DESCRIPTIVE REPORT (HYDROGRAPHIC)

Office No. H-9425

General Locality PRINCE WILLIAM SOUND

VERIFIER'S REPORT
HYDROGRAPHIC SURVEY, H-9425

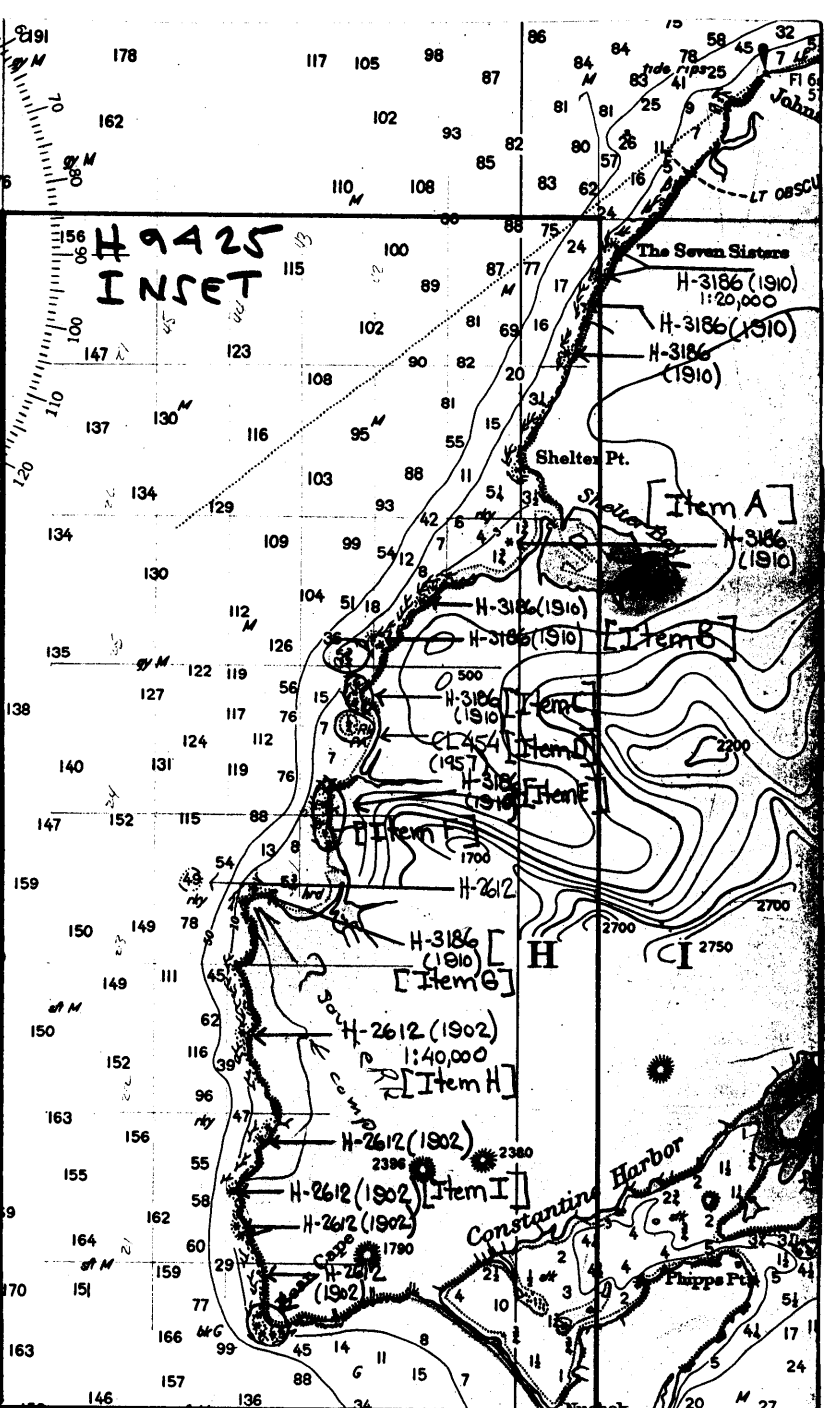
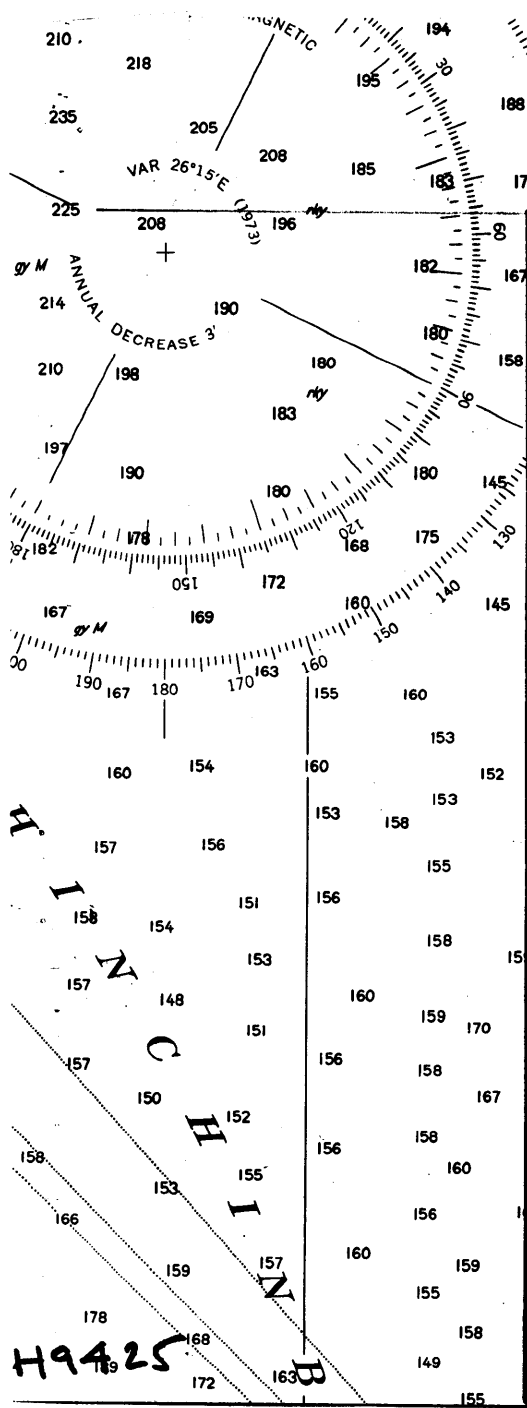
1. The rock, covered $\frac{1}{2}$ -fathom position approximate, was located by the field edit party. This feature lies in the cove west of Shelter Bay at Latitude $60^{\circ}25'56''N$ Longitude $146^{\circ}40'30''W$. (See fix #148 day 200 at 1625; field edit report) It has been reported as a Local Notice to Mariners and is deemed a hazard particularly to any ship intending to anchor in this area. The field edit was accomplished at a minus stage of tide. The rock, however, was located using an inaccurate method of control. Development of this area was done during day 206 at a plus stage of tide. Least depth found was 1 fathoms. Due to the inaccurate methods of location, the verifier recommends that a rock, covered 3 feet, position approximate, at Mean Lower Low Water be charted as presently shown on the chart (16th Ed., 1975) until more precise methods of location can be made.

Field edit not available at time of review. Rock on 55 is shown as 05RK

least depth by hydro is 30 m west of topo position

2. The rock charted at Latitude $60^{\circ}25'49.00''N$ Longitude $146^{\circ}40'12.00''W$ originates with H-3186 (1910) 1:20,000 scale survey. A rock awash was located at a minus stage of tide during field edit at Latitude $60^{\circ}25'47.48''N$ Longitude $146^{\circ}40'13.48''W$. (See fix #99 day 199 at 1416) This rock plots approximately 20 meters southwest of the rock plotted on prior survey H-3186 (1910). The prior survey rock plots directly on line 619-620 day 199 which was run at a high range of tide. Fathograms revealed no indication of shoaling. Verifier believes these to be the same rocks with position discrepancy due to sheet distortion of copied prior survey and datum shift comparison methods. Recommend that a rock, awash at MLLW be charted as located by the field. See the attached chart, Item A.

3. The rock awash on chart 8520 (N.O. 16703) at approximately Latitude $60^{\circ}25'11''N$ Longitude $146^{\circ}41'57''W$ originates with prior survey H-2612 (1902) 1:40,000 as a sunken rock. Field edit party found a rock covered 1 foot at MLLW Latitude $60^{\circ}25'10.14''N$ Longitude $146^{\circ}41'57.19''W$, which corresponds quite closely to this feature. (See fix #76 day 198 at 1506; field edit report) Recommend that a rock awash

symbol be retained on the chart but plotted at the new field coordinates. This feature lies off an extended ledge as depicted on Class III manuscript T-00634. See the attached chart, Item B.

4. The rock awash charted at Latitude $60^{\circ}24'51''$ N Longitude $146^{\circ}42'11''$ W originates from H-3186 (1910) 1:20,000. The ledge limits, on Class III manuscript T-00634 included all other rocks from the prior survey in this area. Verifier could not accurately evaluate the field edit data encompassing the 1910 data. And thus, recommends that this prior rock awash remain as charted. See the attached chart, Item C.

5. The $\frac{1}{2}$ Rk position approximate charted at Latitude $60^{\circ}24'36''$ N Longitude $146^{\circ}42'18''$ W originates with Chart Letter 454 1957. Here, a logger reported to have taken a sounding on the reported rock after his log tow had hung up at the above position. The field edit party found a rock baring six feet at a minus stage of tide Latitude $60^{\circ}24'34.54''$ N Longitude $146^{\circ}42'23.98''$ W (See fix #143 day 200 at 1541; field edit report) After tide correctors were applied, this rock became awash three feet at MLLW. Near this position, another rock was found covered two feet, Latitude $60^{\circ}24'35.35''$ N Longitude $146^{\circ}42'24.43''$ W. (See fix #144 day 200 at 1542; field edit report) This feature reduced to a sunken rock covered five feet at MLLW. Recommend the $\frac{1}{2}$ -fathom PA be shown as a rock awash baring three feet at MLLW as located in this survey. See the attached chart, Item D.

8. The rock awash charted at Latitude $60^{\circ}23'27''N$
Longitude $146^{\circ}43'39''W$ originates with prior
survey H-3186 (1910) 1:20,000. Field edit was
done in this area but interpretation of data for
plotting purposes was unclear to verifier.
Verifier felt most conservative answer was to
retain the prior rock data. Recommend that the
rock as presently charted be retained. See the attached
chart, Item G.
